METROPOLITAN GOVERNMENT OF NASHVILLE AND DAVIDSON COUNTY

STAFF RECOMMENDATION
Ransom Avenue/Byron Close Development
101 Ransom Avenue, Lot 1
September 16, 2015

Application: New construction--infill
District: Elmington Place Neighborhood Conservation Zoning Overlay
Council District: 25
Map and Parcel Numbers: 104100000100CO
Applicant: Barlow Builders
Project Lead: Melissa Baldock, melissa.baldock@nashville.gov

Figure 1. Site map.

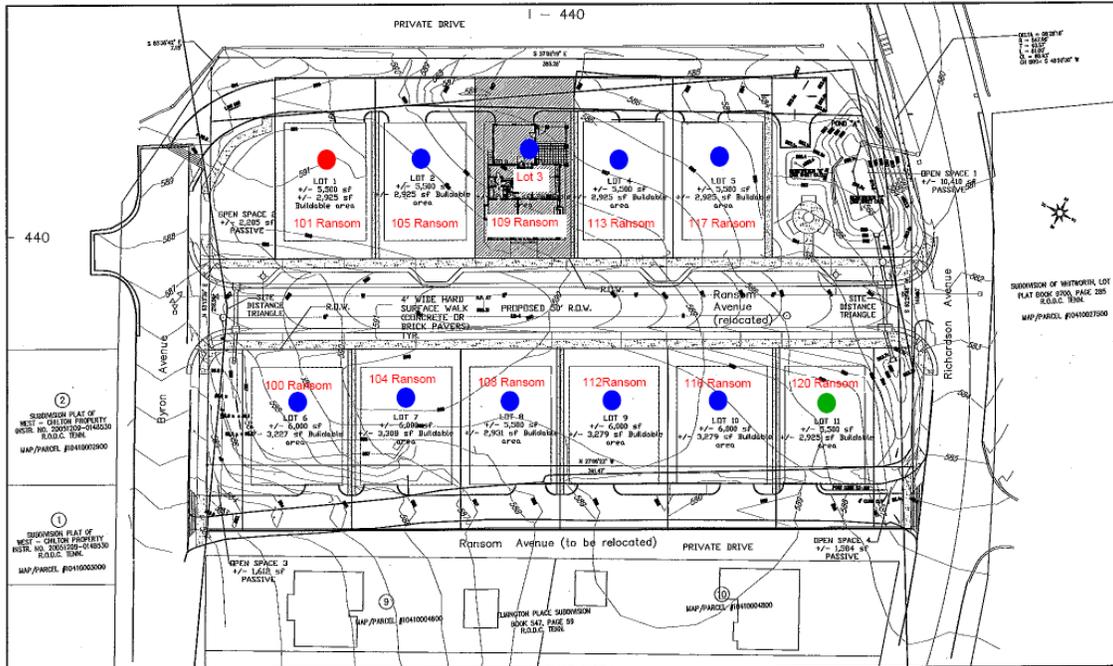
Background: Ransom Avenue/Byron Close is an eleven unit residential SP development (BL2008-149) located on the previous site of Ransom School, close to I-440 and West End Avenue. To date, the Commission has reviewed and approved the design of nine of the eleven houses (Figure 1). Construction on these houses has begun (Figures 2 & 3).

In August 2015, the Commission disapproved a design for Lot 1, 101 Ransom Avenue, because the design's orientation did not meet the design guidelines. This application for Lot 1 represents a new design by the same applicant.

SITE PLAN
OF
LOT 1, BYRON CLOSE SUBDIVISION
PLAT DOC #20131018-0108864
NASHVILLE, DAVIDSON COUNTY, TN.

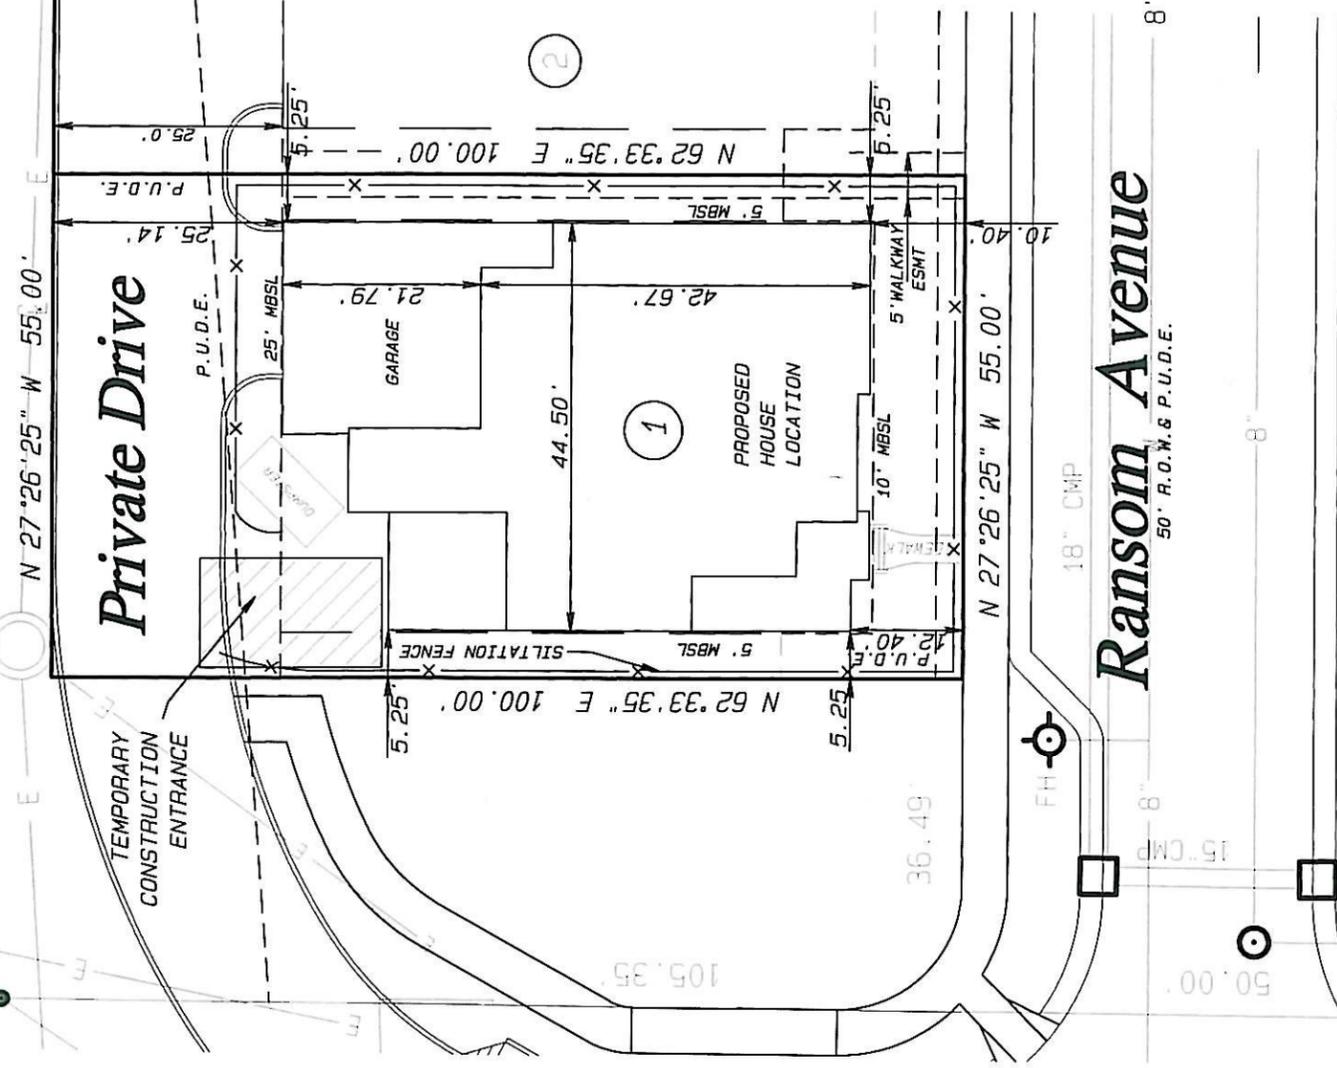
The house will have similar setbacks that were approved as part of the development plan in 2012. The front setbacks will be approximately ten feet (10'), which the Commission has determined to be appropriate for this development in the past. The side setbacks will be a minimum of five feet (5'), and the rear setback will be a minimum of twenty-five feet (25'). These setbacks meet the development plan and have been approved by the Commission for infill in this development in the past. Staff therefore finds that the setbacks and rhythm of spacing meet section II.B.1.c. of the design guidelines.

Vehicular access will be from the rear, accessed by a rear alley. There is a walkway leading from Ransom Avenue to the entryway, which is appropriate.

Appurtenances & Utilities: The location of the HVAC and other utilities was not noted on the site plans, and staff asks that the HVAC units be located on the rear, or on a side façade beyond the midpoint of the house.

- Staff provide final review of the windows and doors, roof color, railing design and material, brick and stone samples, and the material for the entryway and porch floors;
- All siding have a maximum reveal of five inches (5”); and
- The HVAC units be placed on the rear façades, or on a side façade beyond the midpoint of the houses.
